NMP Observed Issues

WDNR CAFO NMP Coordinator

Alfalfa Seeding Years

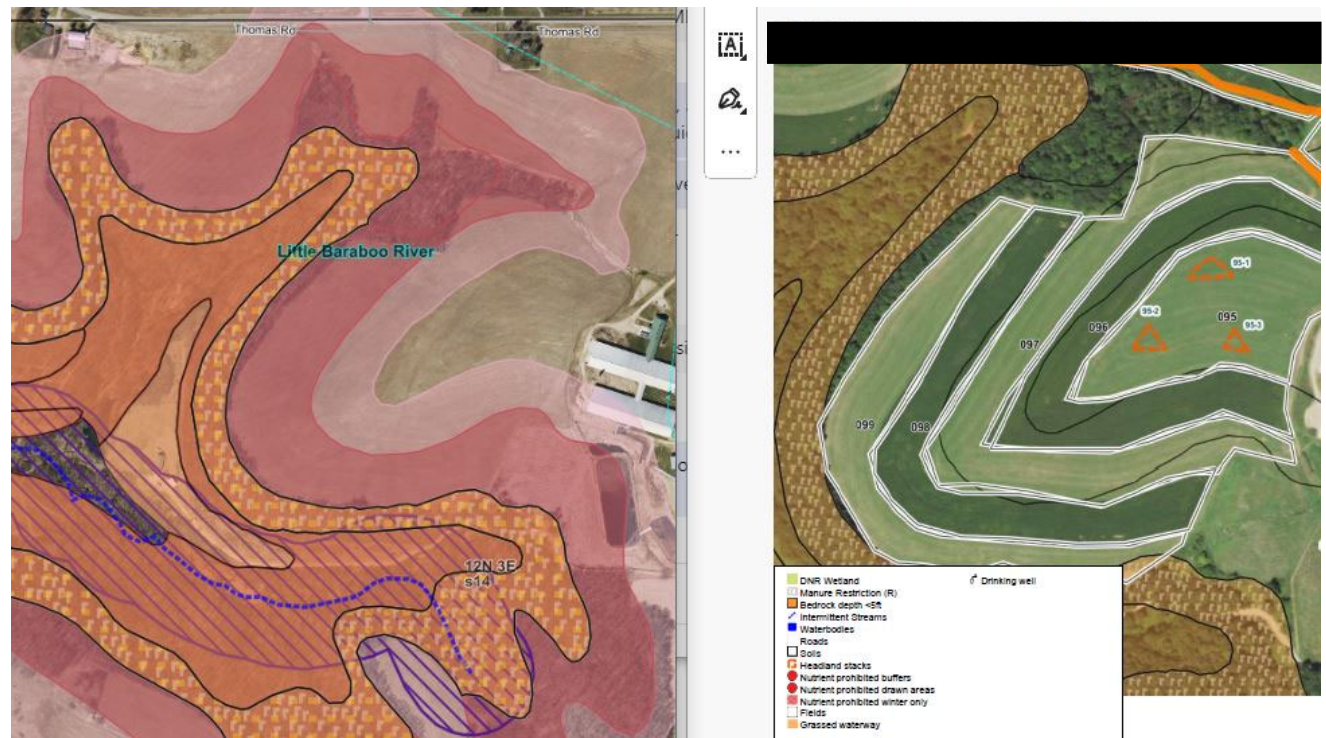
- Alfalfa seeding years not included in crop rotation
 - If a crop rotation involves forage, a seeding year must be included in the rotation years
 - If field is transitioning to row crop only rotation, then seeding year may not be needed
 - If rotation is longer than 8 years, rotation period should be maxed out

Multiple fields merged

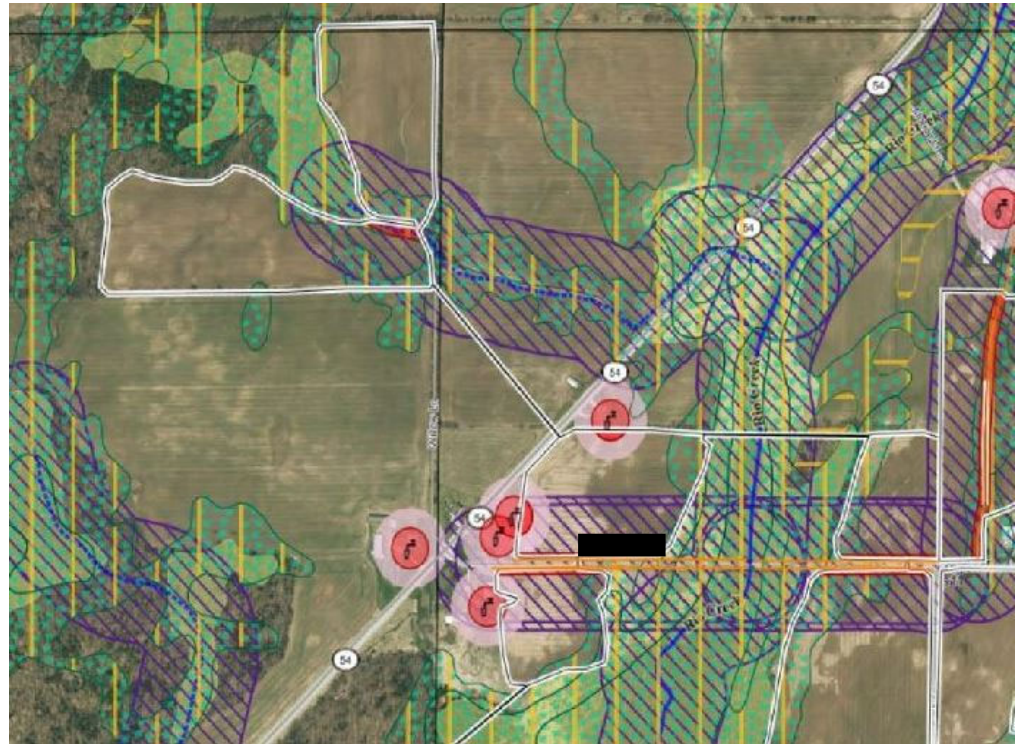
- Multiple fields are being digitized together using thin strips and being managed as a single field
- This creates an inaccurate spreadable acres and misrepresents the field
- In order for multiple fields to be managed as on they must be directly adjacent and have similar field characteristics
- This will require maps to be re-done prior to approval
